# Technical Service Bulletin

## 91 MMI3G+ GPS navigation location inaccurate or navigation takes a very long time to acquire location

91 16 56 2040406/5 July 7, 2016. Supersedes Technical Service Bulletin Group 91 number 15-22 dated October 16, 2015 for reasons listed below.

**Figure 2.** Example of integrated circuit chip without coating (left) and with coating (right). Parts without the coating over the integrated circuit chip are not okay and should be replaced.

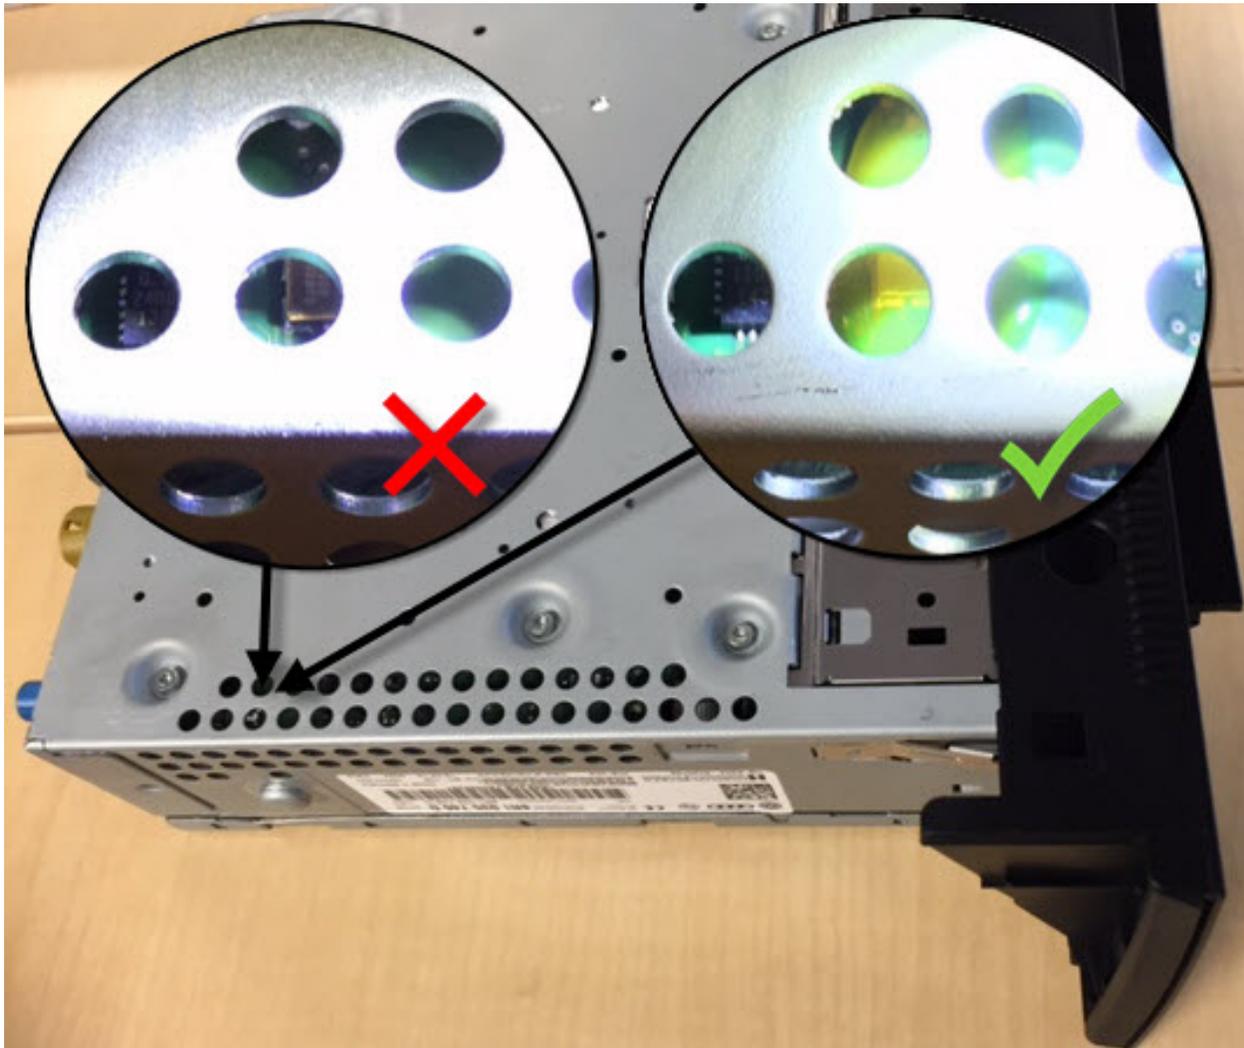
3. Order a replacement MMI main unit using the applicable part number listed in the parts table below. There are different variants of main units that have support for a SIM card slot and some variants that do not. Once the new part arrives, check the integrated circuit chip of the GPS oscillator on the internal circuit board. The chip should have a translucent yellow coating (Figure 2).

Some early service parts did not have the coating despite the updated hardware part number (G suffix) and build date. All parts built after November 08, 2014 should have the coating over the integrated circuit chip. If the part does not have the coating over the integrated circuit chip, return the part and order a replacement.

If the parts department has problems getting updated parts with the integrated circuit chip coating, contact TAC. A small amount of specially modified parts are available for shipping directly from Audi of America.
